City of Alexandria, Virginia

April 19, 2007

**Re: City of Alexandria Comments on Protocols for Air Modeling to Determine
Emission Limitation for Potomac River Generating Station**

Figure 1. All Northern Virginia Measurements in 2006 - PM2.5 24-hour Averages (ug/m3)

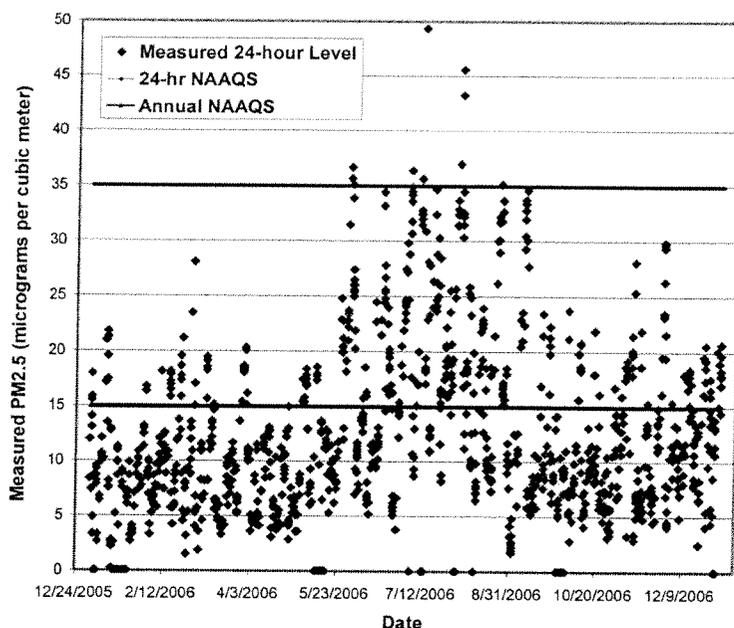
The Commonwealth of Virginia defines primary ambient air quality standards in 9 VAC 5-30-65 (including PM_{2.5}) as the “levels of air quality which, allowing an adequate margin of safety, are necessary to protect the public health.” VDEQ’s enforcement authority in protecting the NAAQS prompted the agency to declare, in August, 2005, that this “facility shall not be returned to operation until it and the associated air pollution control equipment are able to operate without violation of any ambient air quality standard.”¹⁵ The US EPA Region III Director declared federal support for VDEQ’s enforcement action, stating that “for the health and safety of local residents near the plant ... the USEPA will not support any continued full or partial operation of the Potomac River without verification from EPA experts that there will not be any modeled exceedances of the NAAQS caused by emissions from the plant” (Donald S. Welsh, US EPA Region III, to James P. Moran, Congressman, October 21, 2005).¹⁶

PM_{2.5} is a pollutant for which primary ambient air quality standards are defined. In summary, not only is there solid regulatory basis for an air quality analysis that includes the determination of this plant's PM_{2.5} emission limits that demonstrate compliance with the NAAQS, there is also extremely heightened public interest in ensuring that this pollutant be included in the facility's NAAQS compliance demonstration.
